# ***Interactive comment on “Detecting groundwater discharge dynamics from point to catchment scale in a lowland stream: combining hydraulic and tracer methods” by J. B. Poulsen et al.***

Response to reviewers' comments to the manuscript: Detecting groundwater discharge dynamics from point to catchment scale in a lowland stream: combining hydraulic and tracer methods MS No.: hess-2014-369

Fig. 1.

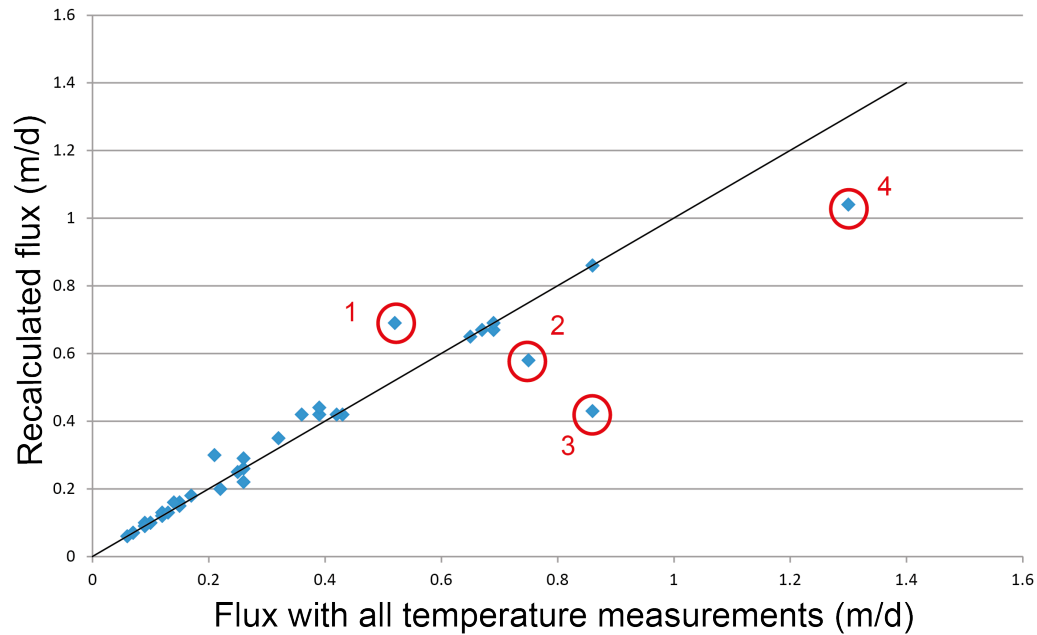
Referee comment #1: Page 13108, Line 3: As far as I saw do you use all the measurements at 0, 0.025, 0.05, 0.075, 0.1, 0.15, 0.2, 0.3, 0.4 and 0.5m below the streambed and the groundwater temperature at 5 m depth to solve the analytical equation. Both Schmidt et al. (2007) and Anibas et al. (2011) recommend that for the steady state analysis only temperature measurements below the zone of diurnal temperature oscillations should be used for the analysis. Usually this is the zone between 0.1 and 0.2 m below the streambed. Otherwise the diurnal influences determine the final result. You use all of them-so it would be interesting to see how much your results would change if only the measurements of 0.15, 0.2, 0.3, 0.4 and 0.5m would be used for analysis! The new flux rates might be lower than the presented ones but would be more reliable and realistic.

Response #1: In our study we used temperature measurements from all depths below the streambed, but we agree with the reviewer that these measurements and consequently also the calculated groundwater fluxes would generally be influenced by the diurnal temperature oscillations. The reason we have such a high density of temperature measurements close to the streambed is that based on our experience with this stream, streambed temperatures become constant at shallow depth, even by 0.5 m below streambed (see reply to next comment), thus these measurements are often necessary to capture the transition from streambed to groundwater temperature. As shown on Figure 4 in the manuscript, the observed diurnal temperature change at the streambed was at most 2.5-3°C for layout B, 1.5-2°C for layouts A and C and most likely

even lower below the streambed. Thus due to the small diurnal oscillations, we do not think that the streambed temperatures recorded by the upper sensors are considerably influenced.

Based on the comment of the reviewer we recalculated the fluxes only using temperature measurements at 0.15 cm and below the streambed surface. Using only these temperature measurements resulted in minor changes in the calculated fluxes (Figure R1). A significant difference in fluxes was only discovered on four occasions (see red circles on Figure R1), where the fluxes were quite high and temperatures close to groundwater temperature were observed close to the streambed (Figure R2). Even on these profiles it is possible to see that removing the upper temperature observations does not change the general shape of the temperature profile calculated by the analytical solution, thus we kept the original flux estimates in the manuscript.

Action #1: No action

Figure R2: Observed temperature profiles (Observed\_all) and fitted temperature profiles using all the temperature observations (Model\_all) and only temperature data below 0.15 m (Model\_deep)

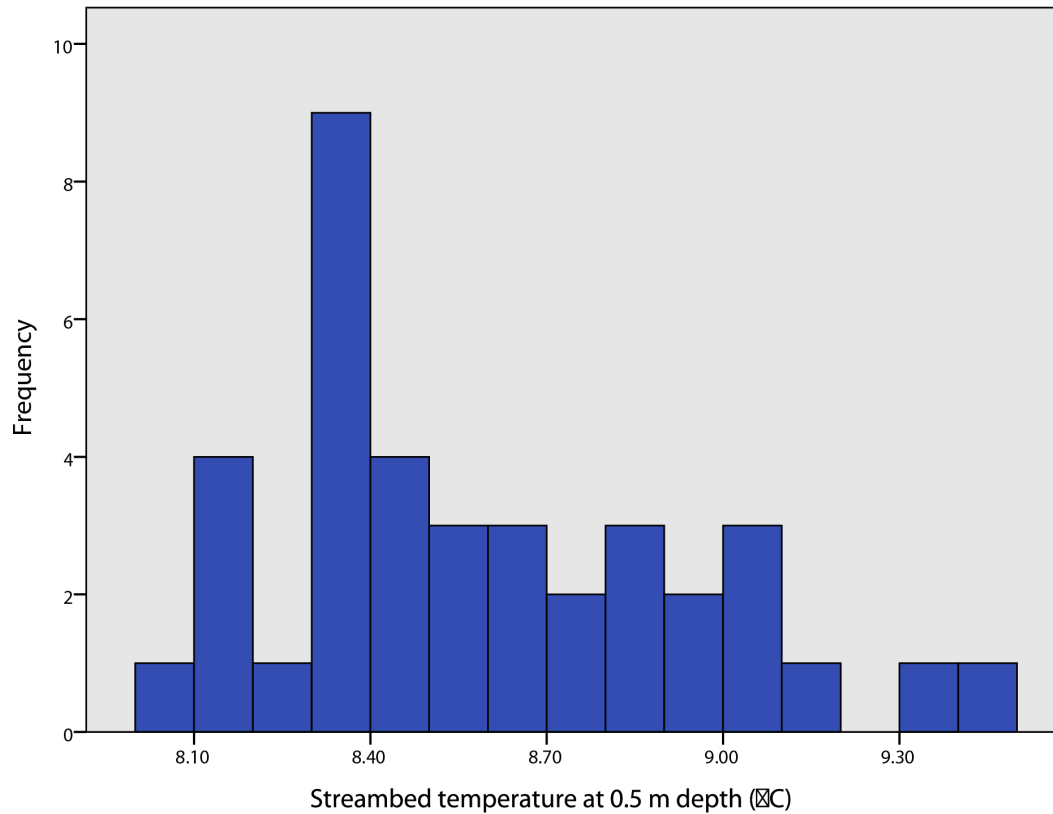
Referee comment #2: P 13115, L 15-28 and P 13115-13116, L 29-5: I could imagine that the spatial trend and distribution of fluxes determined with fewer sensors would fit better with the results of the other methods. Regarding the range of the estimated results; I detected another methodological problem with: You measured the VTP beginning of June, hence in spring, a time when transient seasonal influences on the streambed temperatures are still strong (especially given the location in Northern Europe). Anibas et al. (2009) show that the results of a steady state analysis are sensitive to these seasonal transients. So you have to be aware that your presented results most probably overestimate the real fluxes. The methodology itself does not allow quantifying this effect; however you should discuss or recognize this in your manuscript. To conclude, I think that it is not impossible to do the steady-state analysis with your profiles, but it should be clearly stated that it is difficult to get a reliable quantitative estimate with them. Trends and distribution however should be OK.

Response #2: We agree with the reviewer that in general it is possible to detect sea-

sonal influences in streambed temperatures in June. In the meanwhile we think that in this study due to the high upward fluxes the seasonal temperature differences can be almost entirely neglected. In Denmark groundwater temperature equals the annual average air temperature of around 8-8.5°C. In the majority of temperature profiles this streambed temperature range was reached by 0.5 m depth below the streambed and the highest streambed temperature detected at this depth was 9.42°C (Figure R3).

Anibas et al., 2009 measured annual streambed temperature changes from 7 to 18°C at 0.5 m depth below the streambed (Figure 6 in Anibas et al., 2009), thus in their study streambed temperatures at 0.5 m depth below the streambed show an annual variation of at least 11°C. In this study area the annual variation in streambed temperatures is much less (Jensen and Engesgaard, 2011; Karan et al., 2013). Independent temperature data (collected by thermocouples of an accuracy of 0.2°C) measured at Station 2 (Figure R4), 0.5 m below the streambed shows that the annual temperature variability is much lower in Holtum stream. Considering that the DTS measurements did not identify potential groundwater discharge at the area of Station 2 (Figure 4 in the manuscript), thus the VTP measurements presented in the manuscript are carried out at locations with higher groundwater discharge than shown on Figure R4, we expect the seasonal temperature variations at the VTP locations to be even lower and thus not influencing our flux estimates. A similar annual temperature range was also observed at Station 4 over the hydrological year of 2008 (Figure R5), where a low discharge location (T1) and a high discharge location (T2) show an annual temperature variability of 2°C and less than 0.5°C at 0.5 m depth below the streambed.

Action #2: A sentence about the steady-state assumption was added to the text of the manuscript: 'As previous studies (Jensen and Engesgaard, 2011; Karan et al., 2013) in the same area only detected moderate seasonal changes in streambed temperatures, the steady-state conditions were assumed to be valid for the study period in June.' (p. 7. lines 19-21)
